CITY OF PORTLAND, MAINE  
SITE PLAN REVIEW (ADDENDUM)  
CONDITIONS OF APPROVAL

SITE ADDRESS/LOCATION: 83 Florida Ave.

# APPLICATION FOR AMENDMENT TO PERMIT

Amendment No. 1

NE Solhaugen  
83 FLORIDA AVE  
PORTLAND, ME

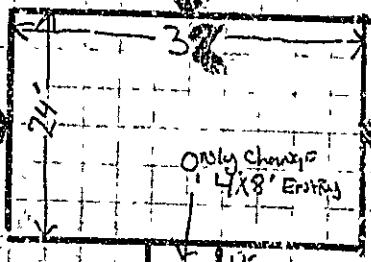
front setback is four feet less

Only change  
4x8 Entry

\* Only difference  
Deduct 4' from  
front set back
